The enclosed Traffic Impact Study (TIS) review letter for the proposed **Wawa Lincoln** (Protocol Tax Parcel: 130-6.00-115.00) commercial development has been completed under the responsible charge of a registered professional engineer whose firm is authorized to work in the State of Delaware. They have found the TIS to conform to DelDOT's Development Coordination Manual and other accepted practices and procedures for such studies. DelDOT accepts this letter and concurs with the recommendations. If you have any questions concerning this letter or the enclosed review letter, please contact me at Annamaria.Furmato@delaware.gov.

RE: Agreement No. 1945F
Project Number 202069012/PO#611882
Traffic Impact Study Services
Task 11-15A –Wawa Lincoln TIS

Johnson, Mirmiran, and Thompson (JMT) has completed a review of the Traffic Impact Study (TIS) for the Wawa Lincoln development, which was prepared by McMahan, a Bowman Company, dated March 24, 2023. This review was assigned as Task Number 11-15A. The report is prepared in a manner generally consistent with DelDOT's *Development Coordination Manual*.

Site Map

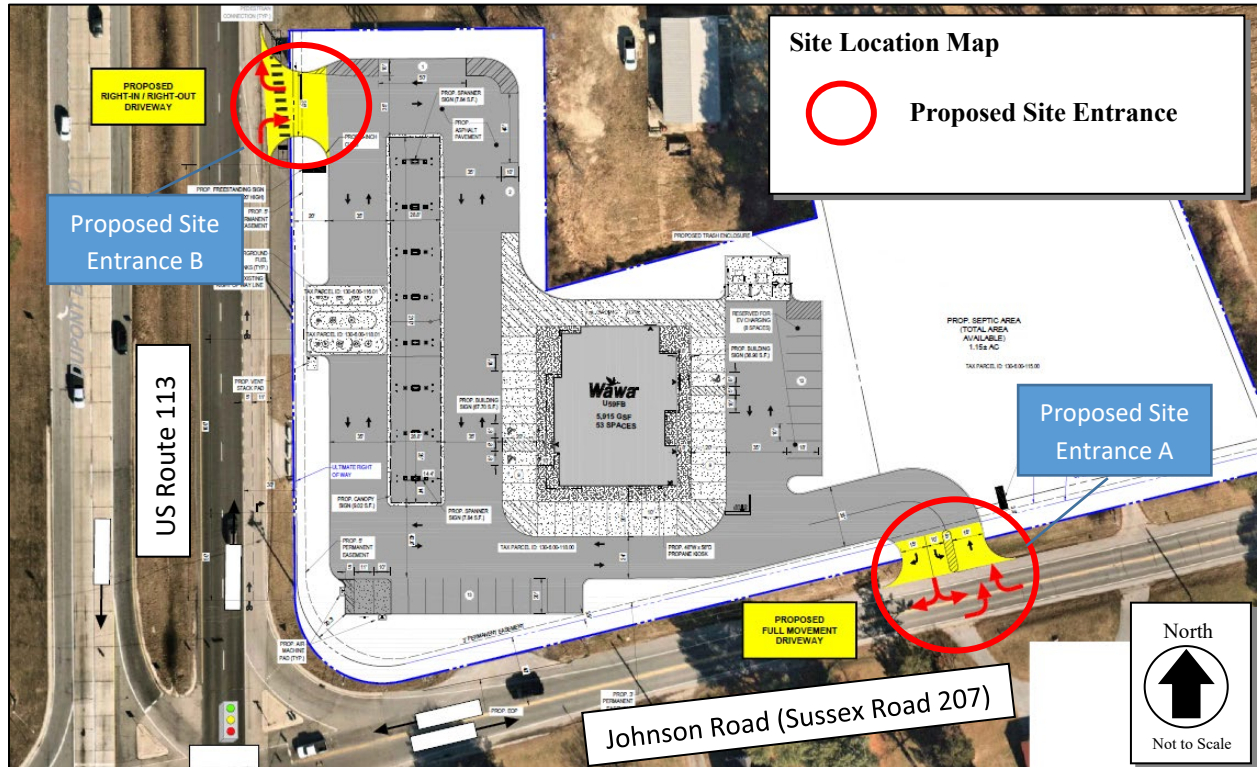
*Graphic is Figure 2 from the Final Traffic Impact Study for the Lincoln Wawa prepared by McMahan, a Bowman Company, dated March 24, 2023. This graphic does not reflect the recommended entrance configurations.
